## TECHNICAL BULLETIN 801-1

**RMESI Model 924 Sampler  
August 2008**

Figure 4. Wide border pattern.

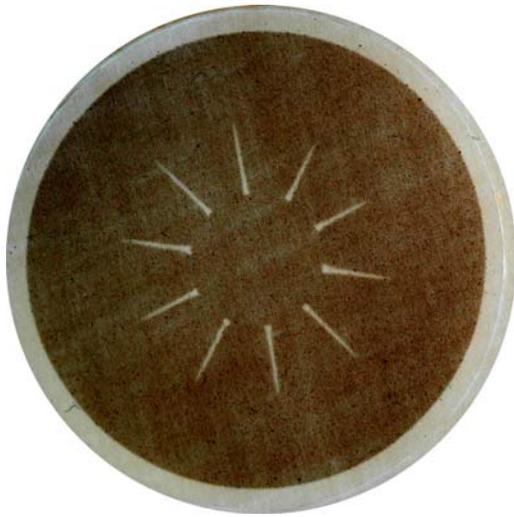
Irregular sample patterns have been observed on some filters collected using RMESI Model 924 Samplers operating at flowrates of 10 LPM. Additionally, in-house testing of a 924 Sampler operated at 10 LPM with both older style filter holders (clear filter holders) and the new filter holders (blue filter holders) resulted in samples with analytical discrepancies. Additionally, improperly installed filter support screens (flipped screens) will result in irregular deposition patterns (see figure 3). See figures 1-2 for examples of **VALID** filter sample patterns. See figures 3-6 for examples of **INVALID** filter sample patterns.

Effective immediately, all RMESI Model 924 samplers should be operated at 12 LPM throughout the year. Additionally, operators should ensure that filter holder screens are properly oriented. If irregular sample patterns are observed the sample should be invalidated and a make-up sample scheduled on the "AQSB RMESI 924 Toxics Data Sheet". The operator should also write "Invalid" on the petri dish containing the invalid filter. The site operator should ensure both the sampler and the filter screens are properly configured before continuing sampling.
